Town of Parker Community Development Department
 Development Review Division
 Attention: **Stacey Nerger**

Application Type: **Site Plan – Non-Residential**
 Status: **First Referral**
 Application Name: Trails at Crowfoot F9 AMD 1 Gas and Convenience Store
 Case/AP#: **SP22-119**
 Referral Received: October 27, 2022
 Comments Due: November 29, 2022

TOWN OF PARKER - FIRE/LIFE SAFETY:	C REVIEWED FOR CODE COMPLIANCE w/COMMENTS
---	--

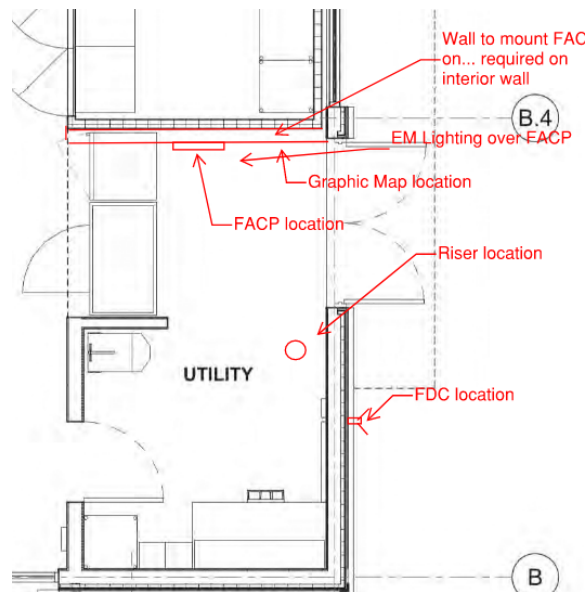
4. The applicant shall provide a room layout that (in advance of a plan set for the commercial building permit) to ensure that the riser room is sized appropriately. With regard to the fire sprinkler control valve room, ensure that the following is addressed: *Not satisfied; the only plan that I found of the interior of the building was on Sheet 16 of 17 in the Site Plan set. This plan showed the entry into the building and a Utility room without showing the locations of the riser and the fire alarm control panel. This room layout is a requirement of Fire Life Safety and must be addressed prior to signoff of the Site Plan. The "fit test" is required to ensure that there is no conflict at time of building review. Address this issue as required.*

- Exterior access is required into the riser room with access into the building provided either adjacent to the riser room or through the riser room.
 - The FACP will be required to be located on an interior wall in the fire sprinkler control valve room; ensure that the riser room is sized to accommodate the FACP and the riser. A three-foot clearance is required in front of the FACP as well as the sprinkler riser.

- The underground shall enter the building and turn up no further than 24 inches from foundation wall; three feet of clearance is required in front of the fire riser with a minimum of 12" of clearance behind the riser and 18" to each side of the riser.

Example of room layout... ensure that all requirements noted above are met:

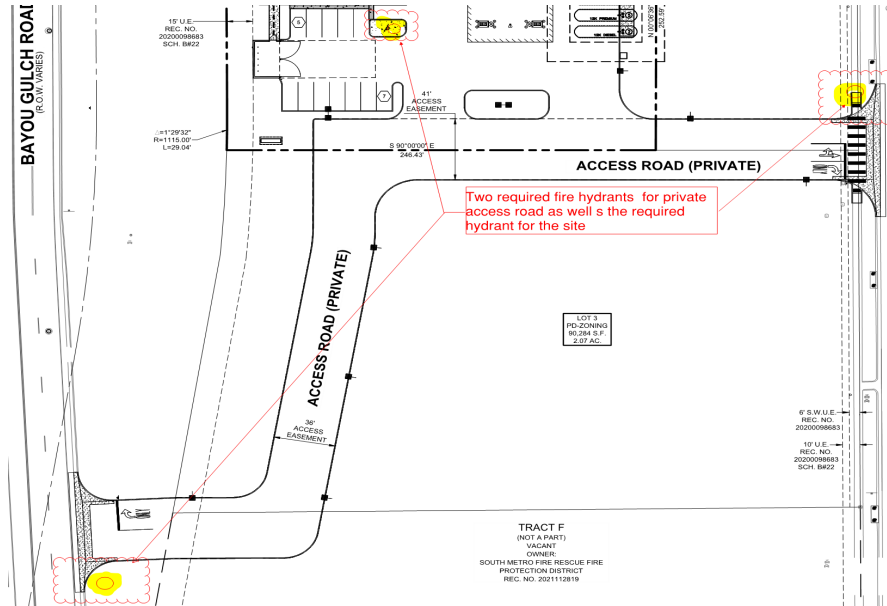
7. **Utility Plan Set:** The applicant shall utilize the correct signature block for Fire Life Safety on the cover page of the utility documents as well as on the overall utility sheet. The applicant shall not use this signature block on any

other pages within the document. This issue must be addressed when resubmitting. *Not satisfied; while the applicant has provided the signature block on the cover sheet, the Fire Life Safety signature block has not been provided on the overall utility sheet as required. Address this issue when resubmitting. Satisfied; applicant has acknowledged or addressed with third submittal.*

Note - An updated signature block has been created with regard to the utility drawing package; typically, this signature block is located on the cover sheet and the overall utility page of the water drawings. The signature block is noted later on in this document, address as applicable.

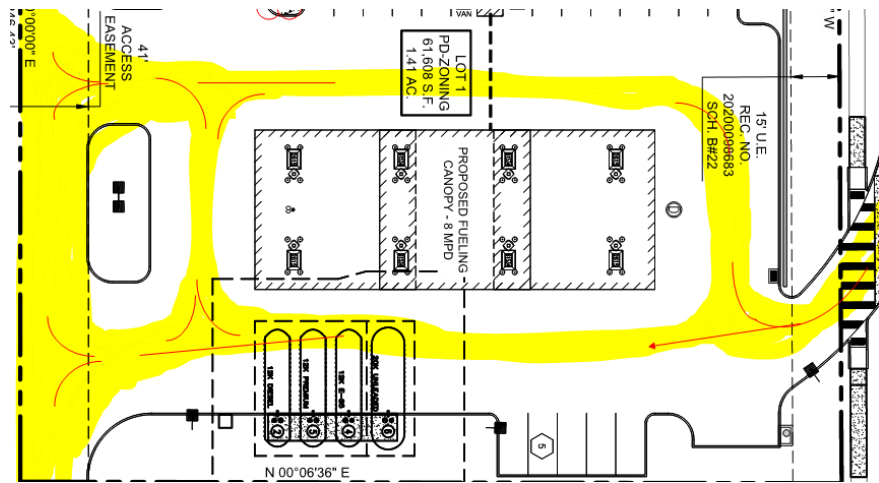
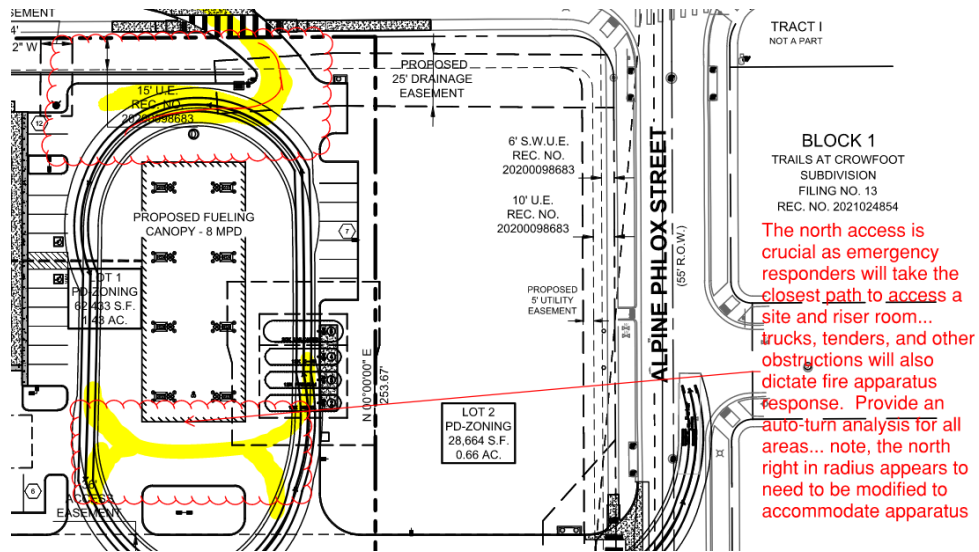
9. The applicant shall provide an auto turn analysis indicating that apparatus can navigate all portions of this site (both sides of the gas canopy); NO PARKING – FIRE LANE signage is required for any portion of the access where the 20-foot clear width requirement cannot be met. This is applicable for the loop around the canopy as well as for each entry. The access on each side of the canopy shall meet his requirement with no portion of the canopy encroaching into the required fire lane access road. See below for the areas required to be included in the auto turn analysis and address when resubmitting (failure to address all locations will result in a delay in approval for this project: *Not satisfied; in addition to what was provided, the applicant shall address what was required... see below... there are two area where the applicant has not provided the auto-turn analysis as required; see below and address when resubmitting:*

Satisfied; applicant has acknowledged or addressed with third submittal.
